Product Change Notice (PCN)

Subject: RA2E2 group I3C function revision

PCN#[MCP-AC-22-0010]

#1 : I²C master; Operation when writing transmission data

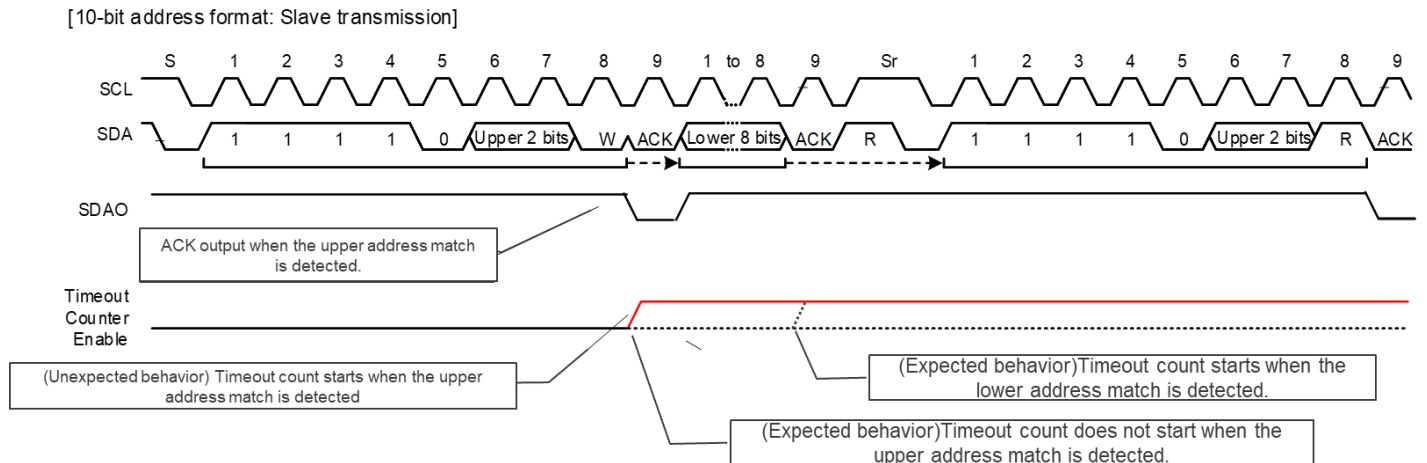
In MCU Ver.1, when the output timing of the first data of the frame and the transmission data write timing are conflicted, the transmission of the first data to be transmitted (b7) will start with a deviation of 1 bit.

MCU Ver.1 requires the software workaround when writing transmission data, but MCU Ver.2 does not require the software workaround.

Note: The following processing is required when checking NTST.TDBEF0 = 1 in Steps [3] and [4] of the I²C master transmission flowchart as shown in Figure 25.104.

After confirming NTST.TDBEF0 = 1, confirm that PRSTDBG.SCILV = 0 (check the status of SCL) before writing the transmission data.

- If BITCNT.BCNT = other than 0 after confirming NTST.TDBEF0 = 1, write the transmission data immediately
- If BITCNT.BCNT = 0 after confirming NTST.TDBEF0 = 1, check that BST.TENDF = 1 and PRSTDBG.SCILV = 0 (check the status of SCL) before writing the transmission data.

Note: [MCU Ver.1 has the following restrictions and workarounds. These restrictions and workarounds are not required for MCU Ver.2.](#)

The following processing is required when checking NTST.TDBEF0 = 1 in Steps [3] and [4] of the I²C master transmission flowchart as shown in Figure 25.104.

After confirming NTST.TDBEF0 = 1, confirm that PRSTDBG.SCILV = 0 (check the status of SCL) before writing the transmission data.

- If BITCNT.BCNT = other than 0 after confirming NTST.TDBEF0 = 1, write the transmission data immediately
- If BITCNT.BCNT = 0 after confirming NTST.TDBEF0 = 1, check that BST.TENDF = 1 and PRSTDBG.SCILV = 0 (check the status of SCL) before writing the transmission data.

#3 : I²C slave; ACK output operation when 10-bit address communication and the lower address mismatch is detected

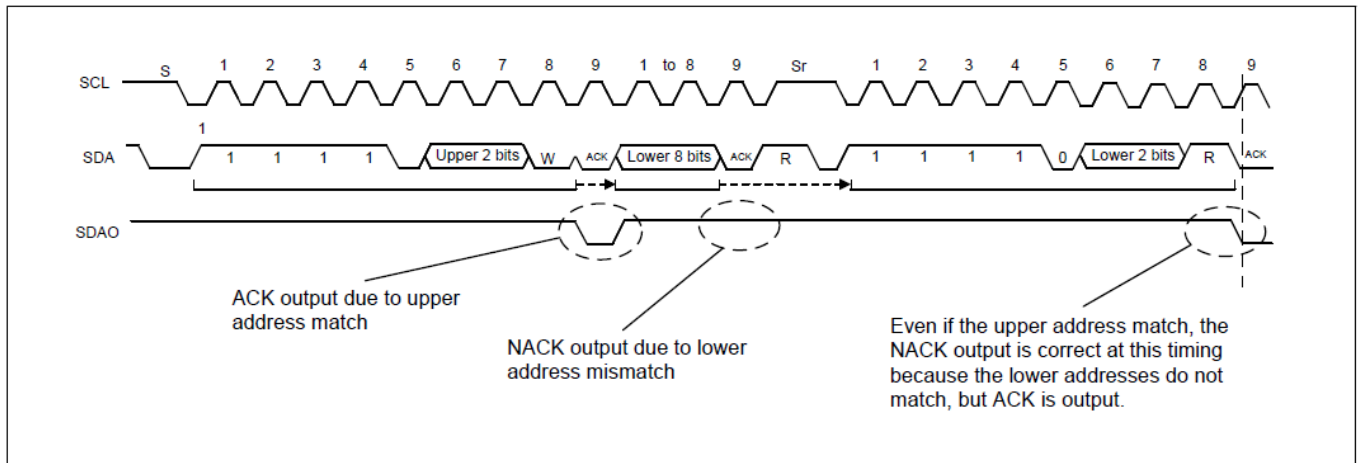
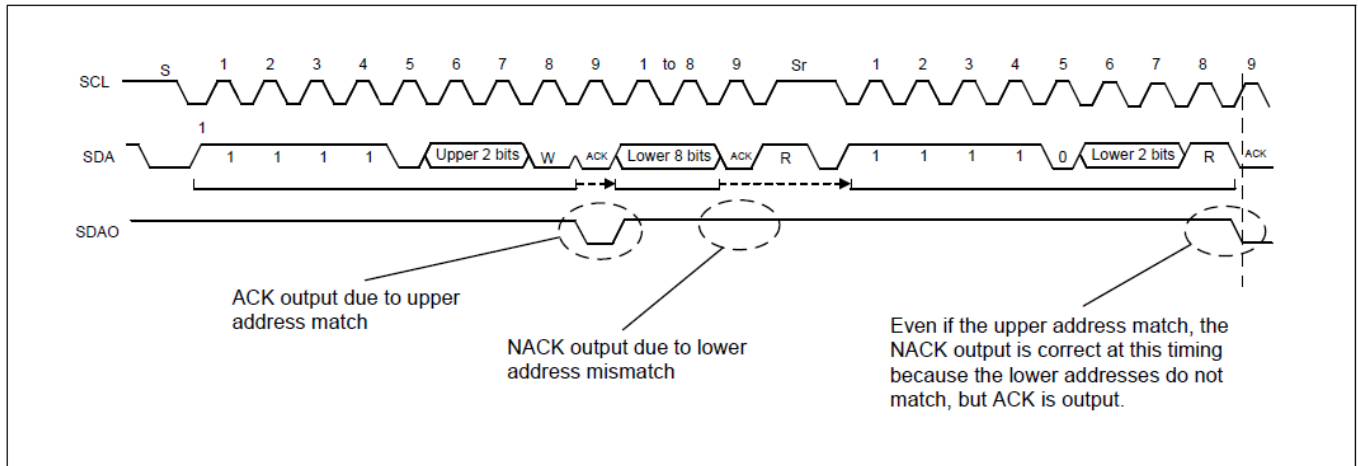
MCU Ver.1 has the following restrictions and workarounds when using 10-bit address communication. The restrictions and workarounds are not required for MCU Ver.2

When multiple I²C slaves are connected to the I²C bus and there is a possibility that an I²C Slave other than this module will NACK for the upper address / R after Repeated START, there are the following restrictions and workarounds.

- Work around : Set the upper 2 bits of the 10-bit address assigned to this module to a value different from other Slave. If the address is exhausted and cannot be set to a different value, use restriction (1).
- Restriction (1) : 10-bit address not available.
- Restriction (2) : After the ACK response in the red circle in the above figure, none of the slaves respond to data, so the SDA keeps the high level and the I²C Master receives the 0xFF data. In the case of a system that can handle 0xFF as abnormal data, 0xFF is read and discarded on the I²C Master side. If 0xFF is valid data, use restriction (1).

MCU Ver.1 has the following restrictions and workarounds. The restrictions and workarounds are not required for MCU Ver. 2.

When multiple I²C slaves are connected to the I²C bus and there is a possibility that an I²C Slave other than this module will NACK for the upper address / R after Repeated START, there are the following restrictions and workarounds.

- Work around : Set the upper 2 bits of the 10-bit address assigned to this module to a value different from other Slave. If the address is exhausted and cannot be set to a different value, use restriction (1).
- Restriction (1) : 10-bit address not available.
- Restriction (2) : After the ACK response in the red circle in the above figure, none of the slaves respond to data, so the SDA keeps the high level and the I²C Master receives the 0xFF data. In the case of a system that can handle 0xFF as abnormal data, 0xFF is read and discarded on the I²C Master side. If 0xFF is valid data, use restriction (1).

4 : I3C slave; Arbitration operation when Dynamic Address is assigned by the ENTDAAs command

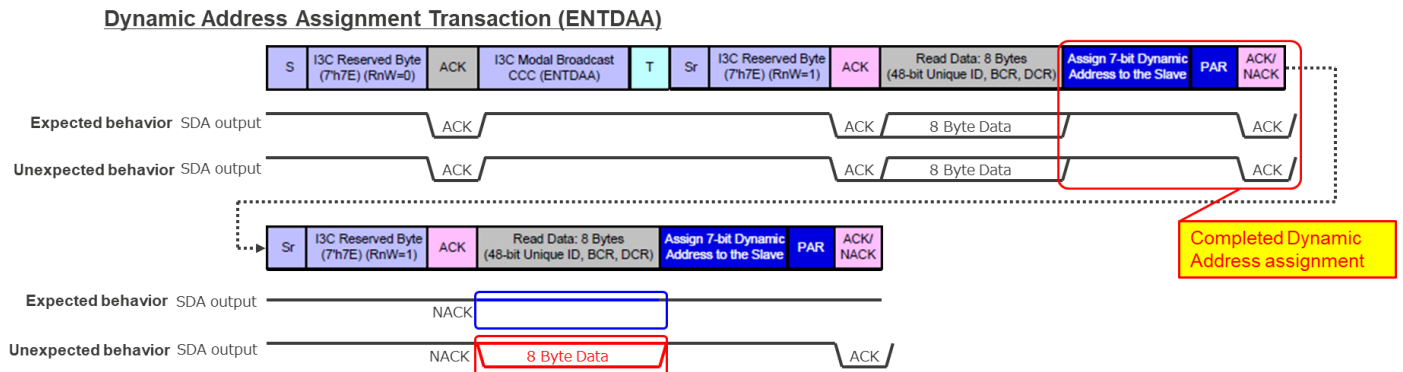
In MCU Ver.1, if a dynamic address is assigned by the ENTDAAs command in I3C slave mode, I3C will participate in dynamic address arbitration in response to the ACK response of other slaves even after the dynamic address assignment.

MCU Ver.1 requires the restrictions and workarounds when assigning dynamic address, but the restrictions and workarounds are not required for MCU Ver.2.

Note: When multiple I3C (I3C Slave) are connected on the I3C Bus assign Dynamic Addresses in the following order.

1. Set the SDCTPIDH and SDCTPIDL registers (6 Bytes) of the I3C (I3C Slave) to a value (All 1 etc.) that has a lower priority than other Slave Devices by Dynamic Address Arbitration.
2. After setting the Static Address in the I3C (I3C Slave), assign the Dynamic Address using the SETDASA / SETAASA command.
3. Assign a Dynamic Address to an I3C Slave Device other than the I3C (I3C Slave) using the ENTDAAs command.

MCU Ver.1 has the following restriction and workaround. This restriction and workaround are not required for MCU Ver.2.

Note: When multiple I3C (I3C Slave) are connected on the I3C Bus assign Dynamic Addresses in the following order.

1. Set the SDCTPIDH and SDCTPIDL registers (6 Bytes) of the I3C (I3C Slave) to a value (All 1 etc.) that has a lower priority than other Slave Devices by Dynamic Address Arbitration.
2. After setting the Static Address in the I3C (I3C Slave), assign the Dynamic Address using the SETDASA / SETAASA command.
3. Assign a Dynamic Address to an I3C Slave Device other than the I3C (I3C Slave) using the ENTDAAs command.

Figure 25.96 Example of error recovery operation flowchart for I3C Master

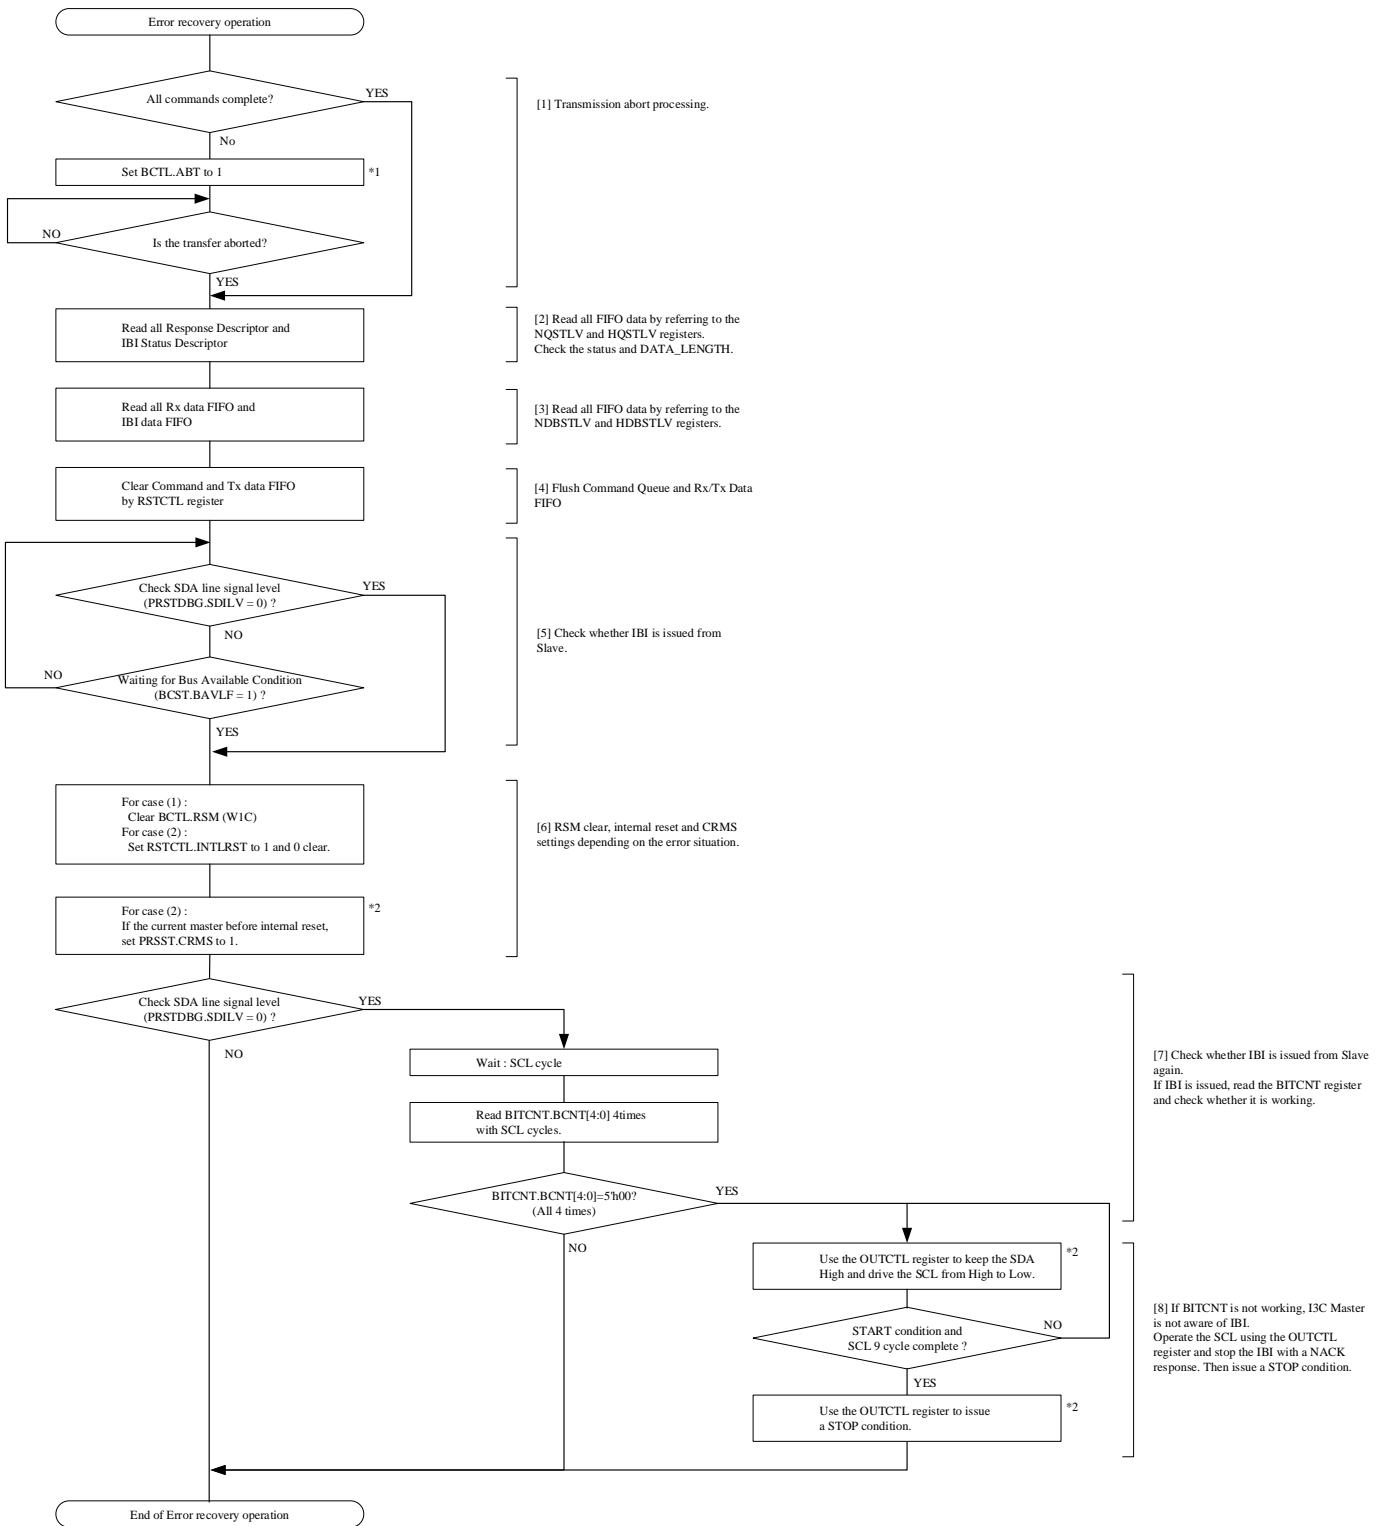
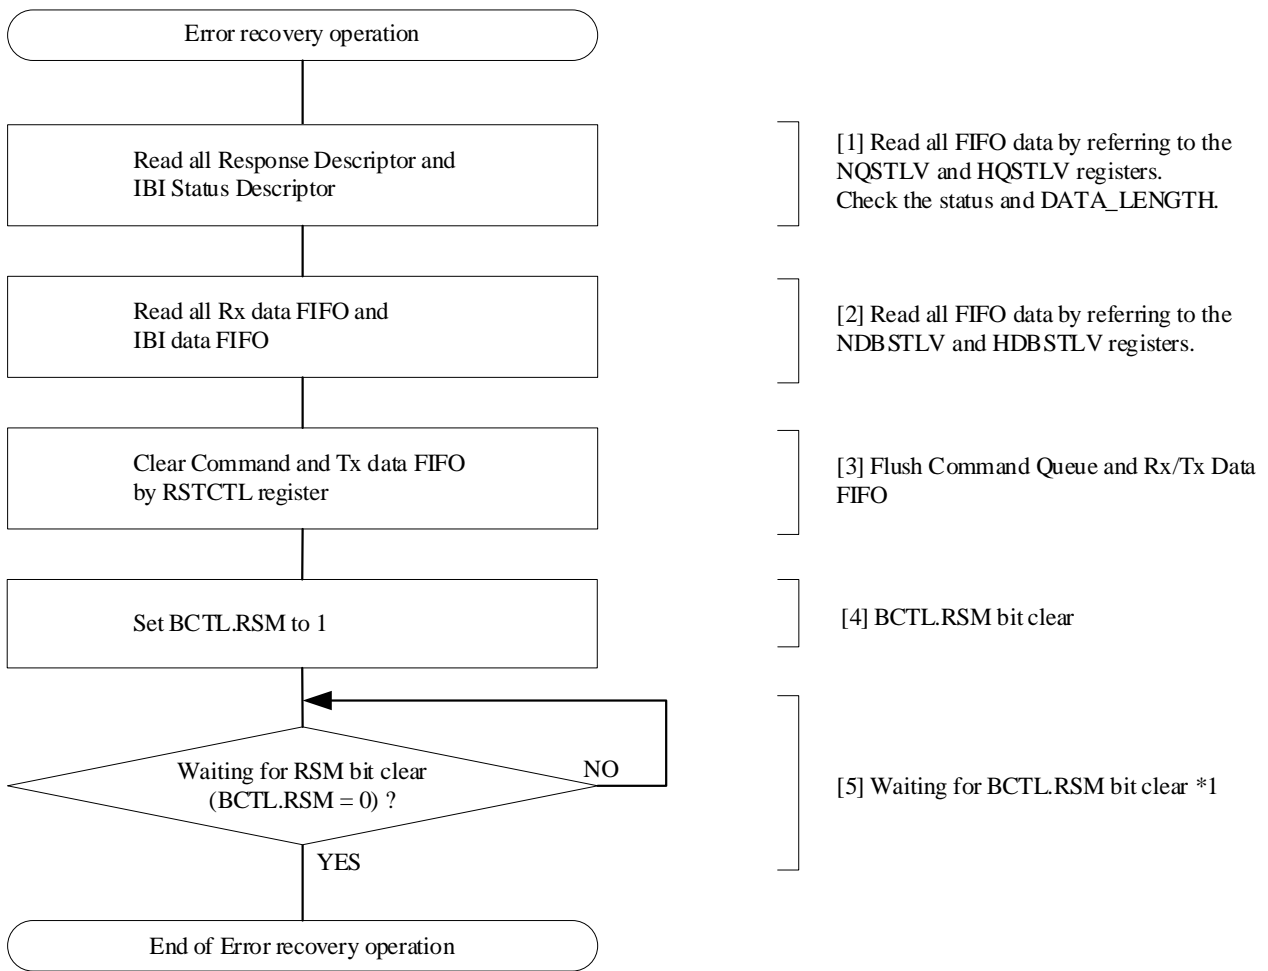
In order to improve the complexity of the error recovery flow, MCU Ver.2 is revised the circuit so that I3C will be suspended (BCTL.RSM becomes 1) when an error occurs. After I3C is suspended, the application must write the value 1 to the BCTL.RSM bit to resume I3C operation and recover form suspended state.

In MCU Ver.2, the error recovery flow shown in Figures 25.96 and Figures 25.97 are simplified by the above improvements.

Figure 25.96 and Figure 25.97 show the error recovery flow.

Note: For MCU Ver.1, apply the following error recovery flow.

Figure 25.96-1 and Figure 25.97-1 show the error recovery flow of MCU Ver.1.

Note: For MCU Ver.2, apply the following error recovery flow.

If an error occurs, I3C will be suspended. (BCTL.RSM becomes 1.) After I3C is suspended, the application must write the value 1 to the BCTL.RSM bit to resume I3C operation and recover from the suspended state.

Note 1. It is possible to set the Command Descriptor while waiting for the RSM bit to be cleared.
